20251316 – BL313 – EIGENMANN HALL – Add Heat Exchanger to Chilled Water Loop
Addendum 2

July 14, 2026

BL313 – Eigenmann Hall – Add Heat Exchanger to Chilled Water Loop
Indiana University Bloomington
IU 20251316

M101

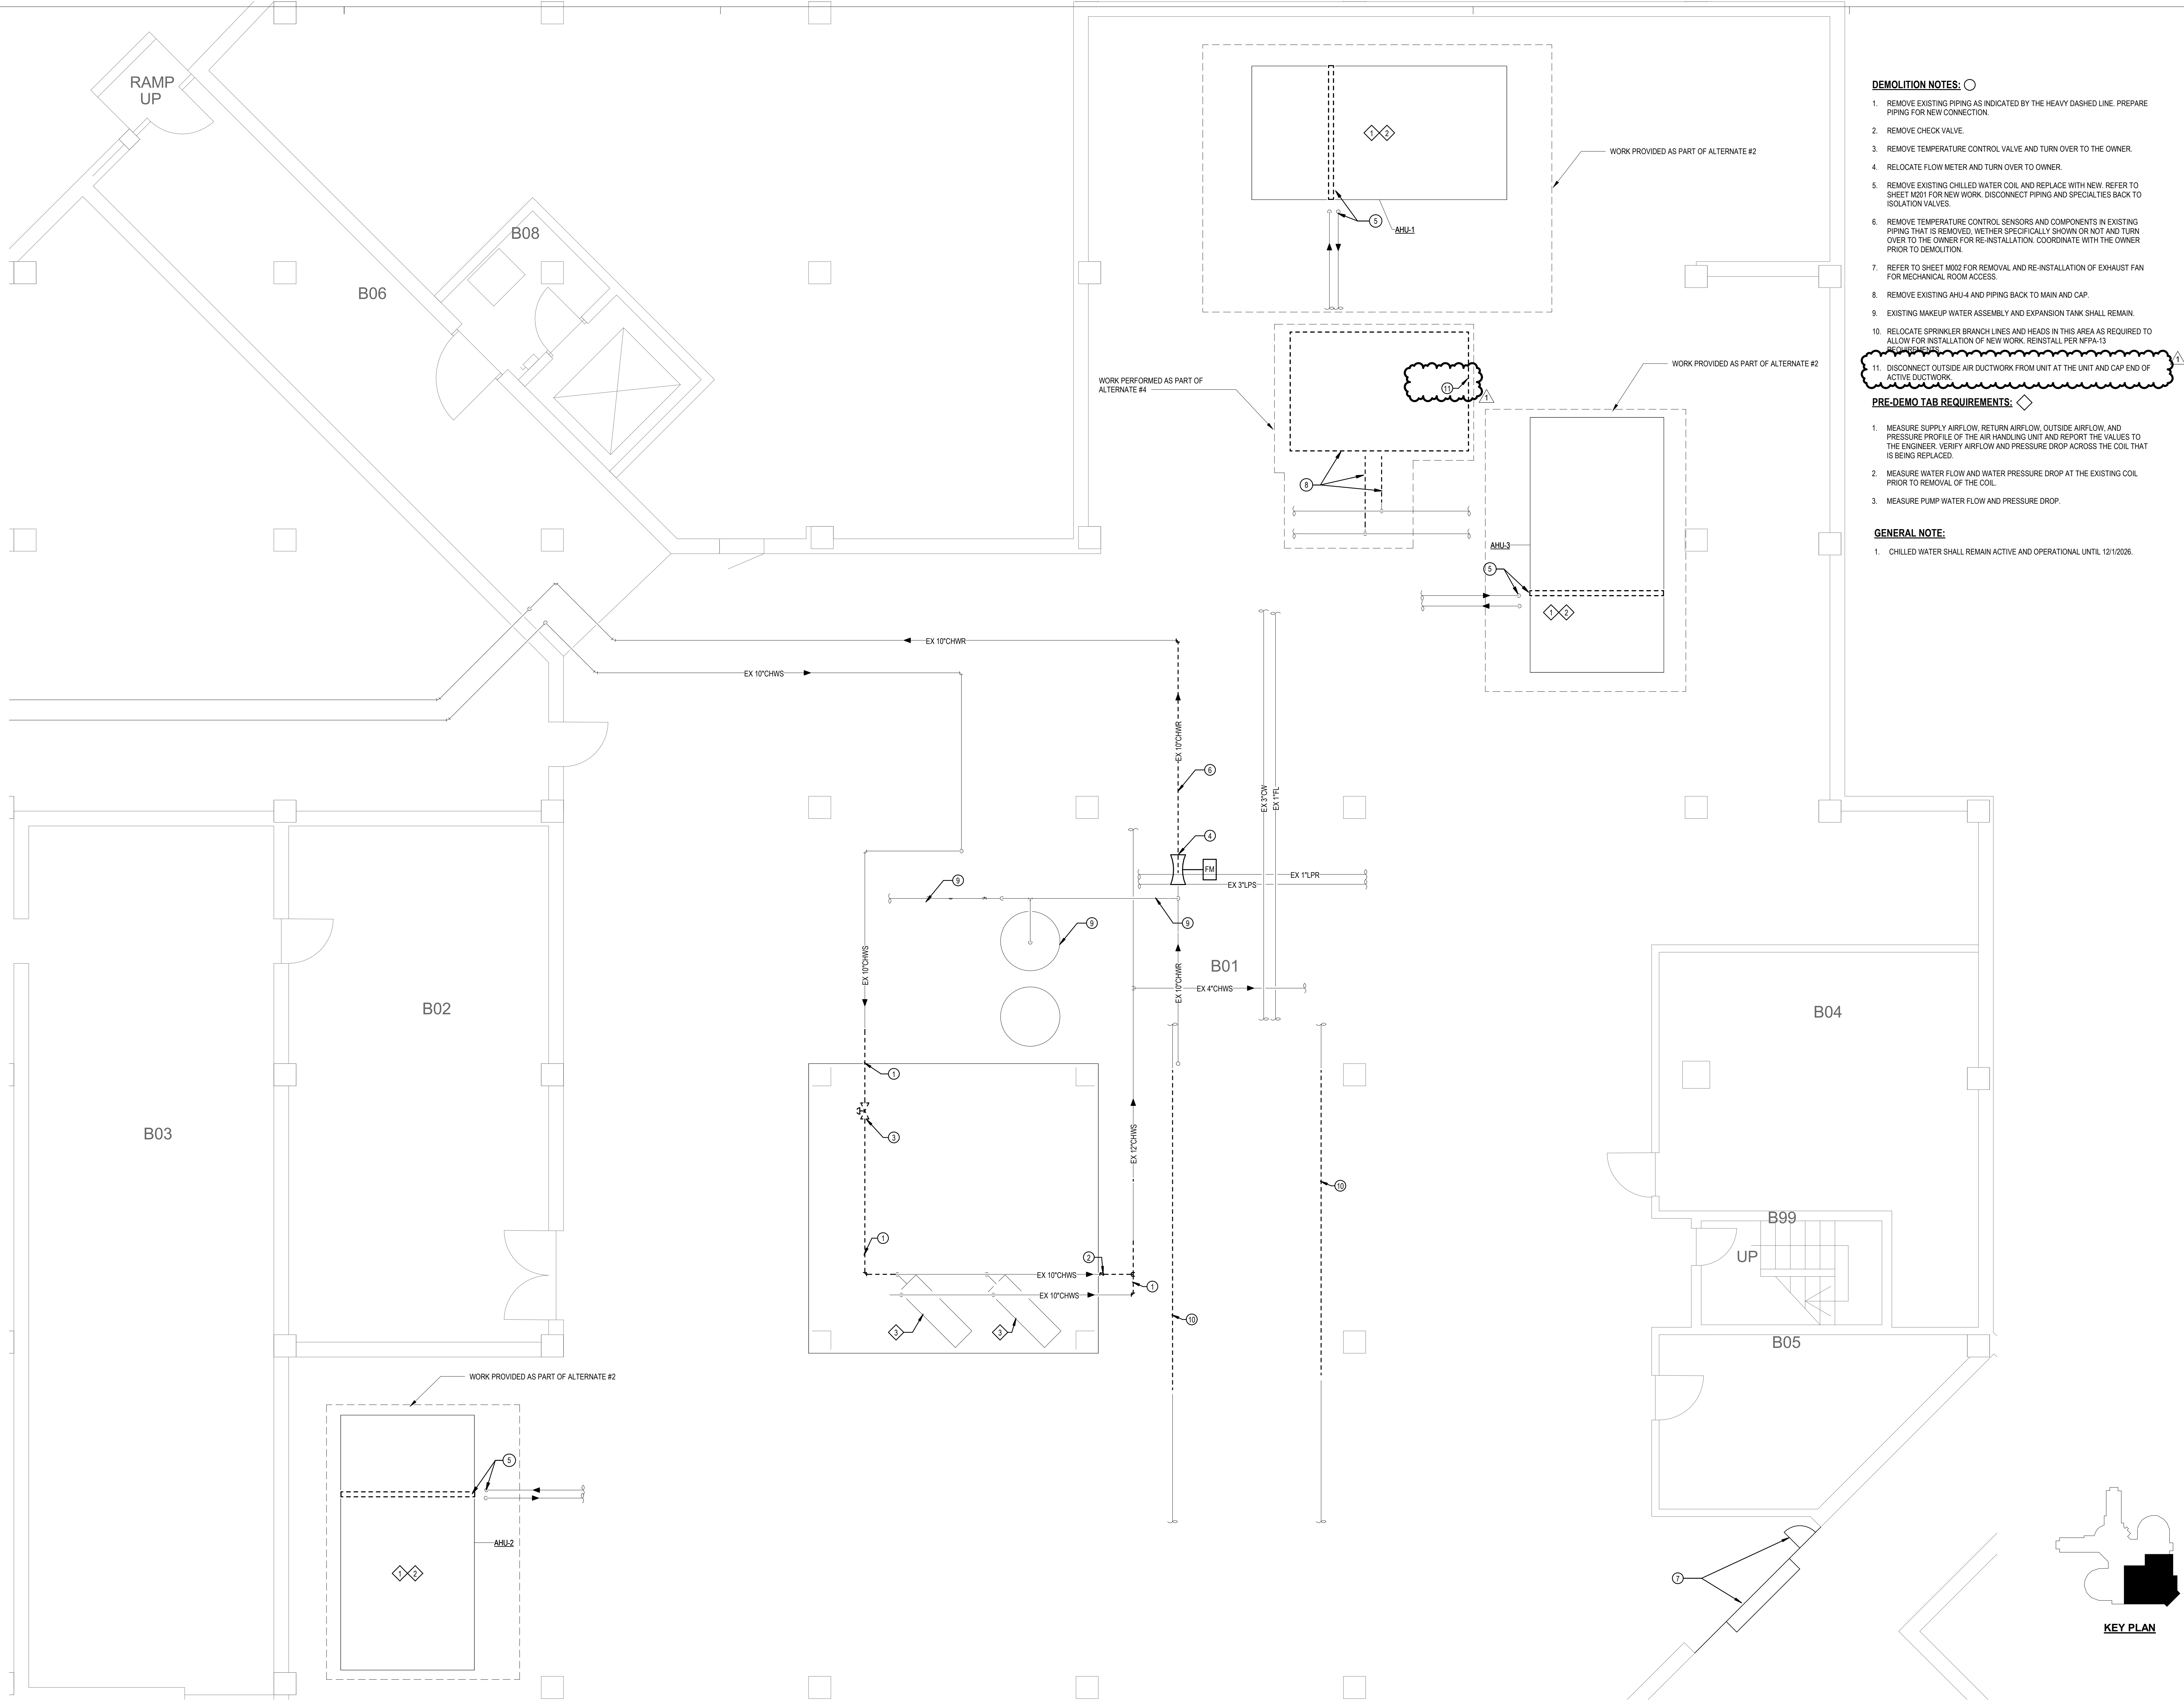
Sheet M101 – EIGENMANN HALL BASEMENT MECHANICAL DEMOLITION PLAN

1. Revise as indicated in the clouded areas on the attached revised sheet.

Drawing Number:
M103

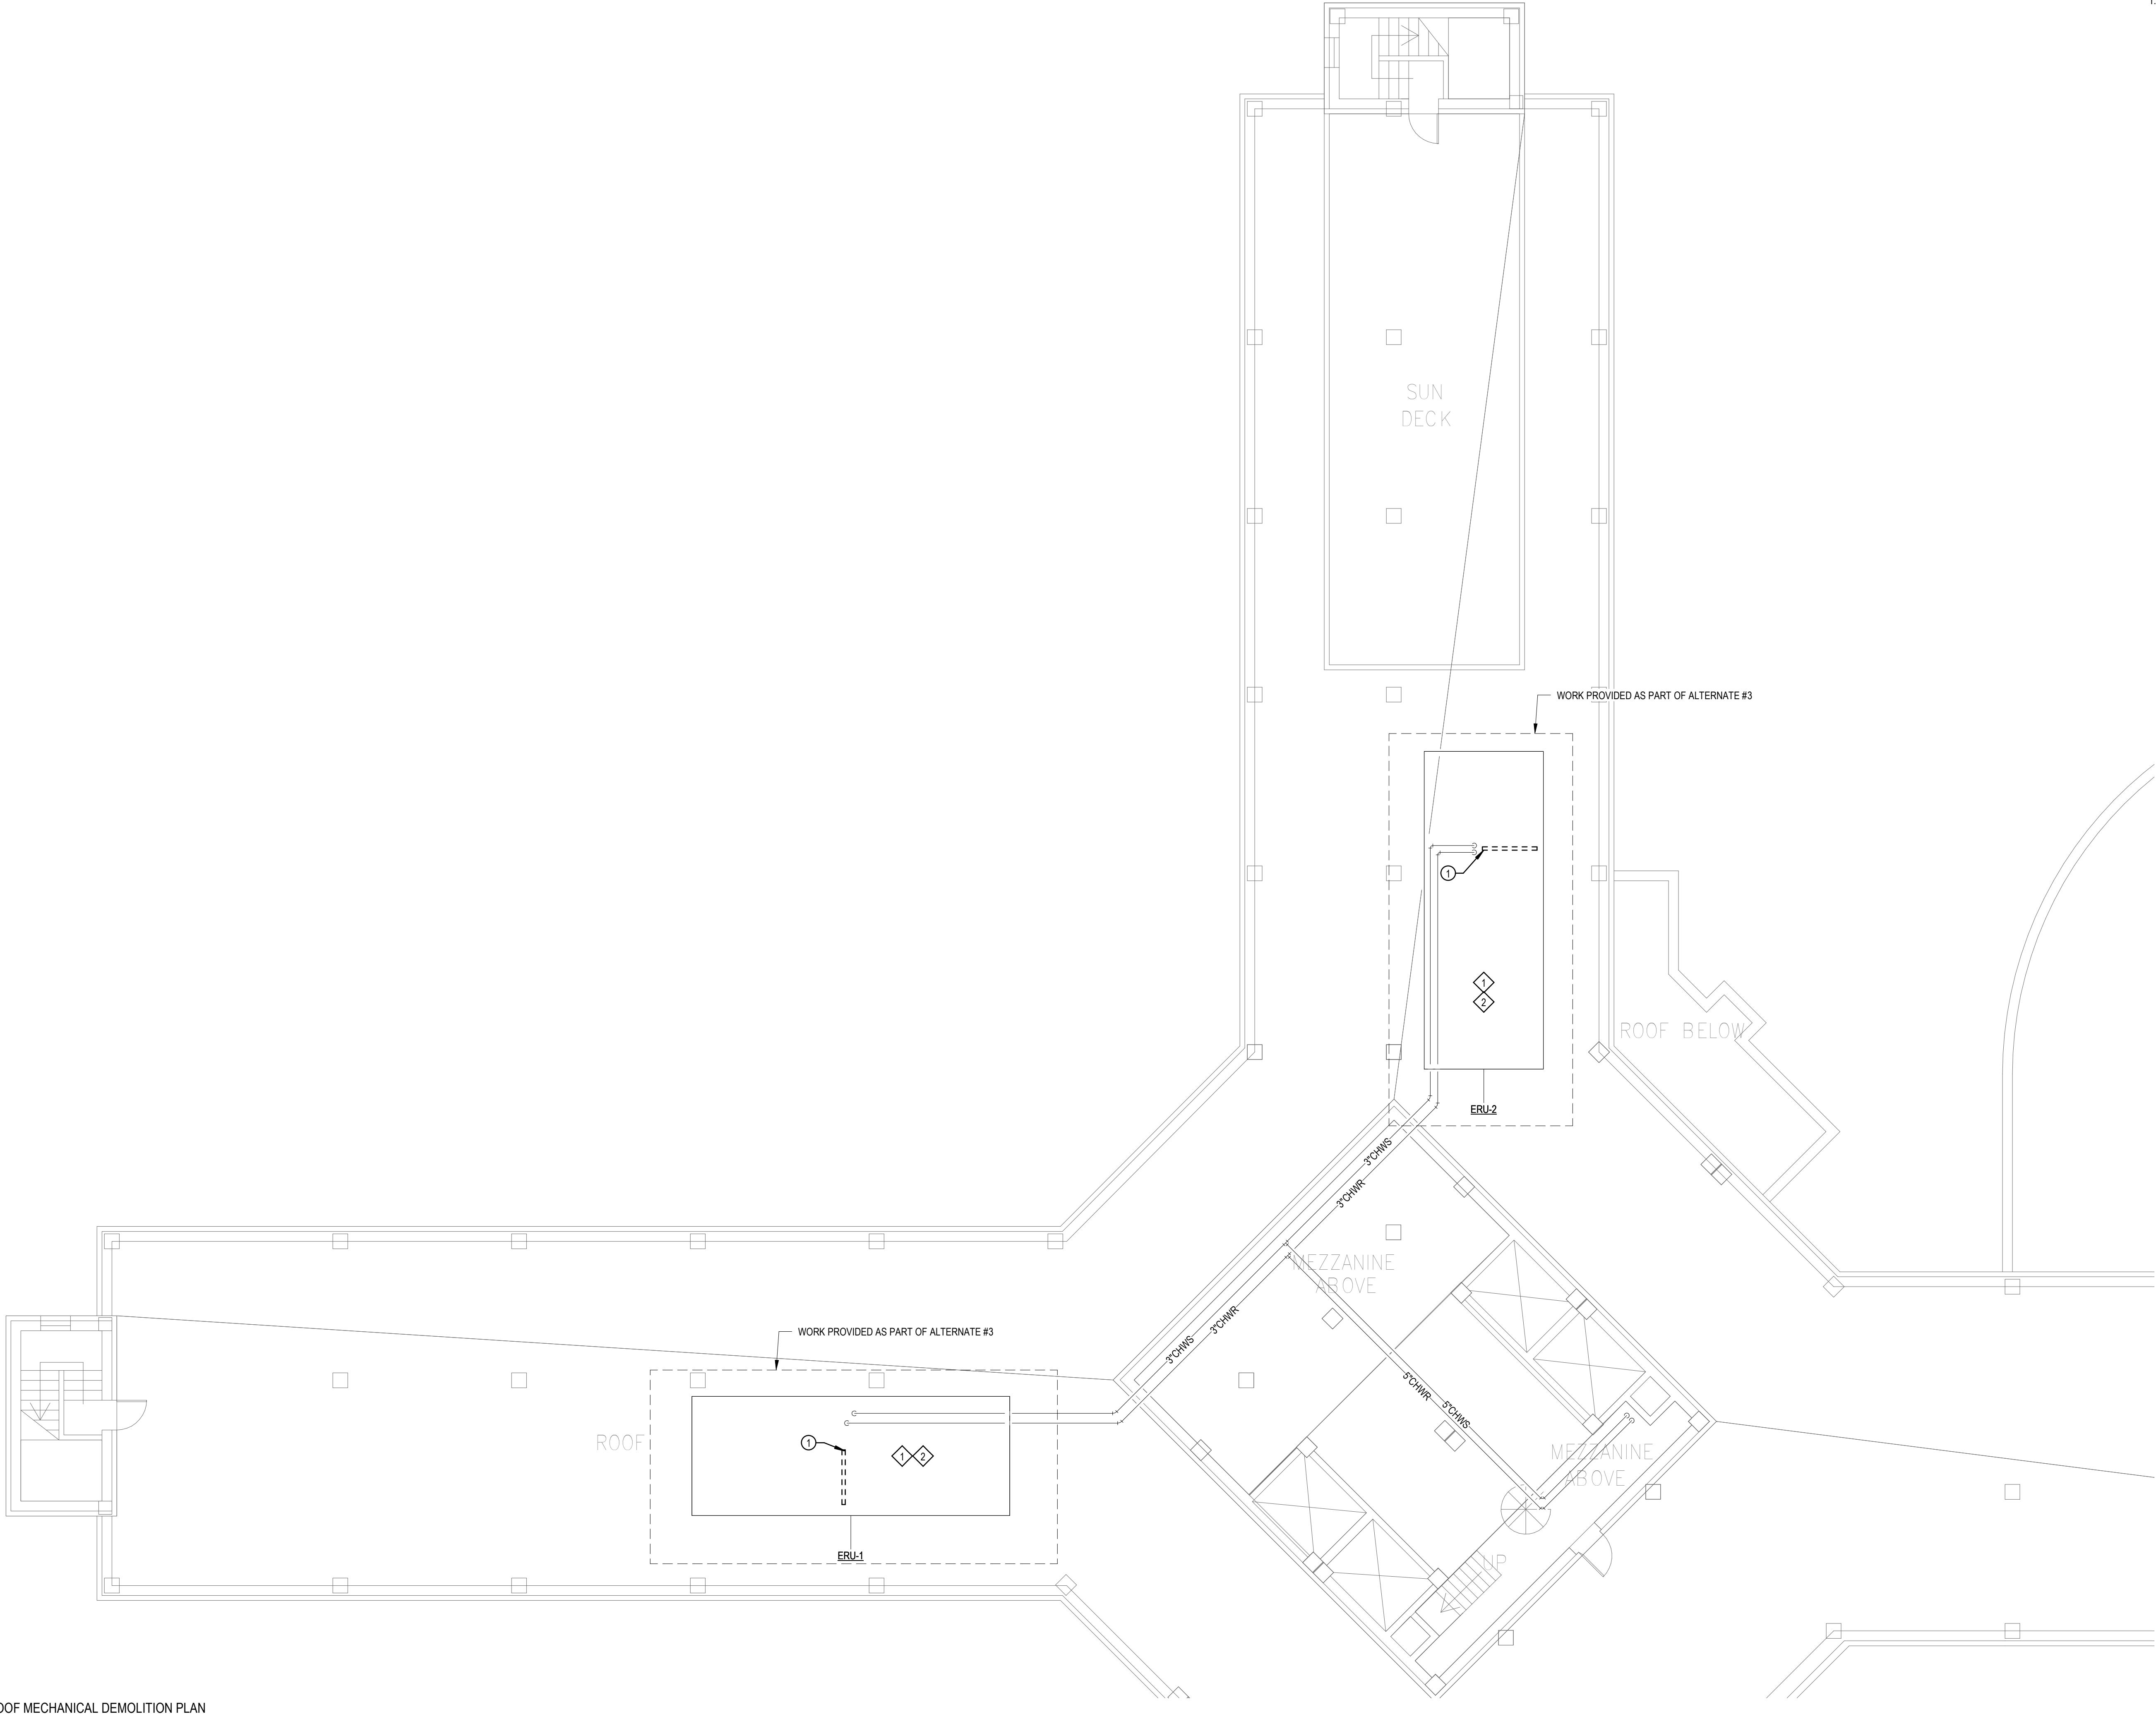
Question 1: On sheet M103, Plan Note 1 implies that the chilled water piping is to be removed back to the isolation valves which are in the mechanical penthouse. Please clarify.

Sheet M103 – EIGENMANN HALL ROOF MECHANICAL DEMOLITION PLAN

1. Revise as indicated in the clouded areas on the attached revised sheet.

Answer 1: Refer to the revised sheet M103 included in this addendum. The piping that is located within the mechanical room and the exterior horizontal pipe chase shall remain. The hydronic specialties and control valve shall be replaced.

- DEMOLITION NOTES:** ○
- REMOVE EXISTING CHILLED WATER COILS AND DISCONNECT PIPING AND REMOVE SPECIALTIES AND CONTROL VALVE. ISOLATION VALVES AND CONTROL VALVE ARE LOCATED IN THE MECHANICAL PENTHOUSE. EXISTING PIPING IN THE HORIZONTAL PIPING CHASE AND MECHANICAL ROOM SHALL REMAIN.
- PRE-DEMO TAB REQUIREMENTS:** ◇
- MEASURE SUPPLY AIRFLOW, RETURN/EXHAUST AIRFLOW, OUTSIDE AIRFLOW AND PRESSURE PROFILE OF THE AIR HANDLING UNIT AND REPORT THE VALUES TO THE ENGINEER. VERIFY AIRFLOW AND PRESSURE DROP ACROSS THE COIL THAT IS BEING REPLACED.
 - MEASURE WATER FLOW AND WATER PRESSURE DROP AT THE EXISTING COIL PRIOR TO REMOVAL OF THE COIL.
